13. Zoning By-law Amendment – 1050 and 1060 Bank Street
Modification au Règlement de zonage – 1050 et 1060, rue Bank

File Number: ACS2020-PIE-PS-0080

SUBJECT: Zoning By-law Amendment – 1050 and 1060 Bank Street

1050-1060 Bank Street | Formal Review | Site Plan Control Application | KWC Architects; James B. Lennox & Assoc.; Holzman Consultants Inc.

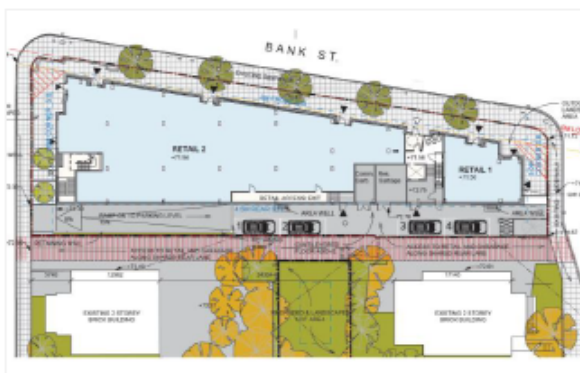
- The Panel expressed strong support for project, how it has evolved, and the contribution that it will make to the neighbourhood. Several recommendations were offered to help finesse the scheme.

- The Panel supports the reinstatement of the rear lane and is pleased to see that the setback has been increased. A through-lobby may now be possible.
- The Panel acknowledges the need for vehicle parking, but would recommend additional bicycle parking on the site.

- The proposal has evolved nicely from the previous version and the clarity of the massing and architectural articulation holds the site better. The alignment of the break in the front façade with the main entrance, the finer proportions of the side facades, and the two-storey units with access to the roof are strong architectural moves.
- Consider integrating a second break in the front façade, similar to where the main entrance is, perhaps located between the two proposed retail units, if "Retail Unit 2" is split into two.
- The negative corners and delamination of materials is supported.
- The Panel is divided on the necessity of the gateway signage. It would be possible to achieve a similar effect by strengthening the architectural expression of the corner and the treatment of the top to have it read as a beacon.

- There appears to be a missed opportunity to strengthen what will be phenomenal views looking out towards the Rideau Canal from the building.
- Ensure that the cantilevered balconies at the corner are not value-engineered. A support column would detract from the design of the most important corner of the building.

- The use of high-quality natural materials is commendable.
- The stone treatment of the base at the southeast corner (where the coffee shop is proposed) should fully wrap the corner onto the Bank Street façade.
- Fritted glass is recommended for the balconies to obscure the inevitable clutter which will be on them.
- Consider using curtain wall system as opposed to window wall.
